**AGENDA
CITY OF CEDAR FALLS, IOWA
PLANNING AND ZONING COMMISSION MEETING
WEDNESDAY, FEBRUARY 13, 2019
5:30 PM AT CITY HALL**

TO: Planning and Zoning Commission
FROM: Iris Lehmann, Planner II
Matt Tolan, Civil Engineer II
DATE: February 7, 2019
SUBJECT: Greenhill Village Townhomes II – Preliminary Plat

TO: Planning and Zoning Commission
FROM: Iris Lehmann, Planner II
DATE: February 7, 2019
SUBJECT: Greenhill Village Townhomes II – Site Plan

PROJECT NO. 56
SHEET NO. C-300

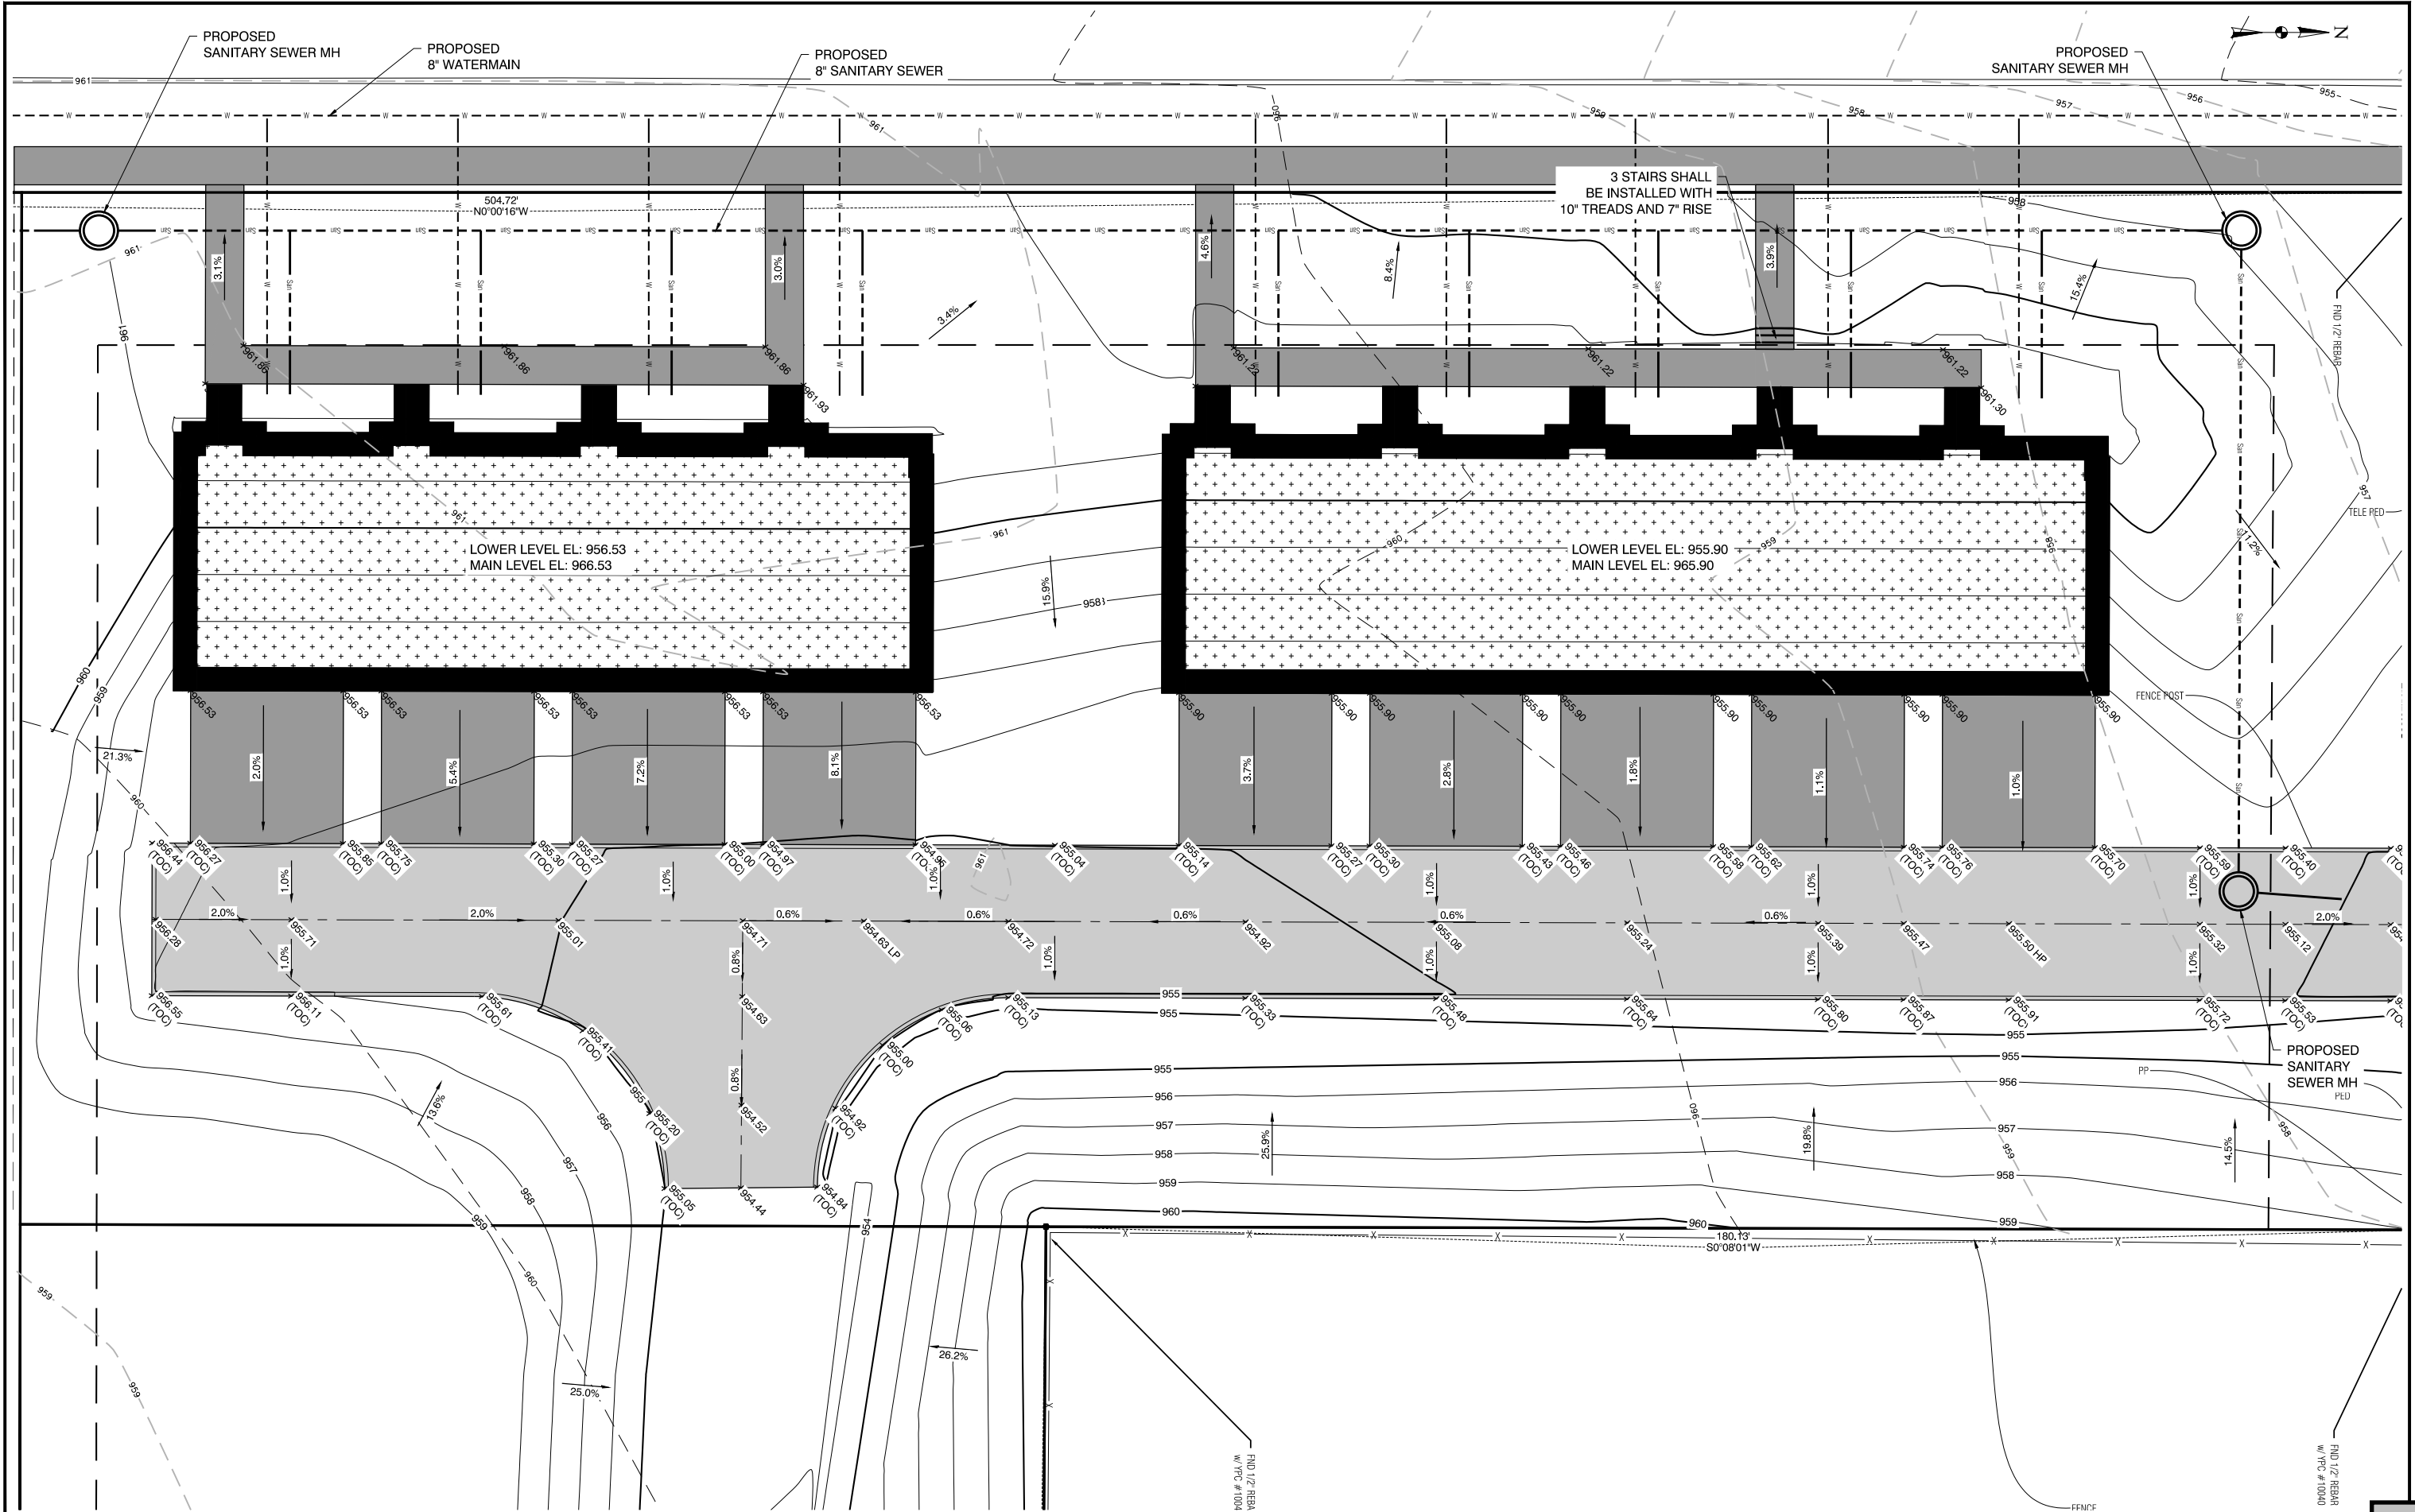
3. Add sidewalk along the eastern lot line of Tract B.
4. Add note for future sidewalk along the south side of Lot 1
5. On sheet C.300 remove "(By OTHERS)"
